TENDER ADDENDUM AND CLARIFICATION No. 9 (TAC 9)

RE: Procurement of Plant, Design, Supply and Installation of the 220kV Mariakani - Dongo Kundu Transmission Line and Associated Substations (KETRACO/PT/045/2023)

A. ADDENDUM NO. 9.

- a) Power Line Aerial Markers Specifications

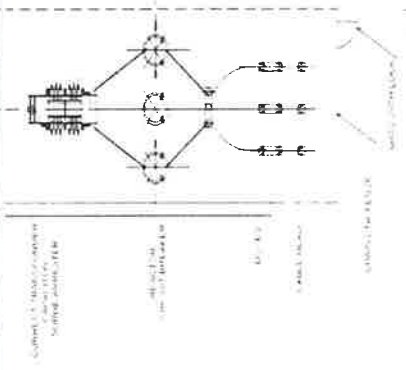
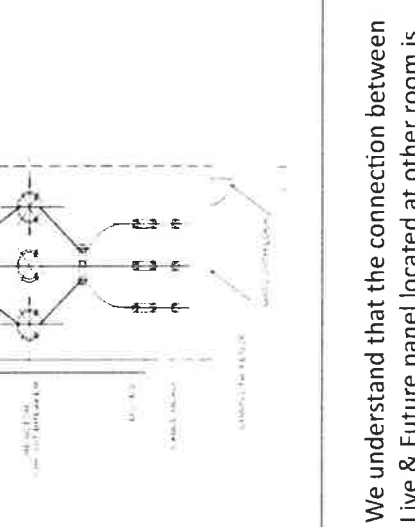
The following section has been modified as attached to this Tender Addendum and Clarification No. 6.

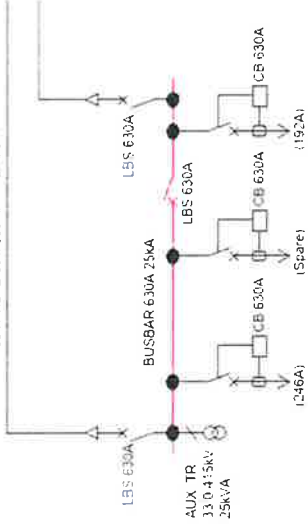
No.	Volume Part / Page	Section / Clause No.	Reference	Clarification	Reply from KETRACO
14	02-Section-VI-2A – Scope of Work – Substations - 20230704	A. Electrical Engineering Requirement 1. DONGO KUNDU 220/33kV SUBSTATION 1.5 Storage Batteries, Chargers, DC switchboards and Inverter equipment VI-2A-9 (PDF Pg.10/47)	<p>1. Storage Batteries, Chargers, DC switchboards and Inverter equipment</p> <p>Substation Batteries, Chargers, DC switchboards and Inverter equipment shall be shown on the drawings and specified in the BOM, equipment and materials to be substation including the BOM to be provided to supply the following work:</p> <p>1. 220V and 33kV storage battery, charger, DC switchboard and Inverter equipment.</p> <p>2. 220V and 33kV storage battery, charger, DC switchboard and Inverter equipment.</p> <p>3. 220V and 33kV storage battery, charger, DC switchboard and Inverter equipment.</p> <p>4. 220V and 33kV storage battery, charger, DC switchboard and Inverter equipment.</p> <p>5. 220V and 33kV storage battery, charger, DC switchboard and Inverter equipment.</p> <p>6. 220V and 33kV storage battery, charger, DC switchboard and Inverter equipment.</p> <p>7. 220V and 33kV storage battery, charger, DC switchboard and Inverter equipment.</p> <p>8. 220V and 33kV storage battery, charger, DC switchboard and Inverter equipment.</p> <p>9. 220V and 33kV storage battery, charger, DC switchboard and Inverter equipment.</p> <p>10. 220V and 33kV storage battery, charger, DC switchboard and Inverter equipment.</p> <p>11. 220V and 33kV storage battery, charger, DC switchboard and Inverter equipment.</p> <p>12. 220V and 33kV storage battery, charger, DC switchboard and Inverter equipment.</p> <p>13. 220V and 33kV storage battery, charger, DC switchboard and Inverter equipment.</p> <p>14. 220V and 33kV storage battery, charger, DC switchboard and Inverter equipment.</p> <p>15. 220V and 33kV storage battery, charger, DC switchboard and Inverter equipment.</p> <p>16. 220V and 33kV storage battery, charger, DC switchboard and Inverter equipment.</p> <p>17. 220V and 33kV storage battery, charger, DC switchboard and Inverter equipment.</p> <p>18. 220V and 33kV storage battery, charger, DC switchboard and Inverter equipment.</p> <p>19. 220V and 33kV storage battery, charger, DC switchboard and Inverter equipment.</p> <p>20. 220V and 33kV storage battery, charger, DC switchboard and Inverter equipment.</p>	It is also understood that a single UPS can accommodate SACS and other necessary emergency loads. Kindly provide confirmation.	Refer to the Drawing No. MSEZ-2022-SS/E-004, "110V DC Power AND 230V Inverter Supply System.

15	02-Section-VI-2A – Scope of Work – Substations - 20230704	A. Electrical Engineering Requirement 1. DONGO KUNDU 220/33kV SUBSTATION 1.5.3 Inverter System for Substation Automation & Control System (SACS) VI-2A-10 (PDF Pg.11/47)	<p>Inverter System for Substation Automation & Control System (SACS):</p> <p>2 Nos. – Inverter with automatic load transfer facility by means of automatic transfer system, instrument and alarms described in the Specification, faults indicated on the SACS.</p>	Apart from SACS, is any other load required UPS supply. Please clarify.	Refer to the Drawing No. MSEZ-2022-SS/E-004, "110V DC Power AND 230V Inverter Supply System.
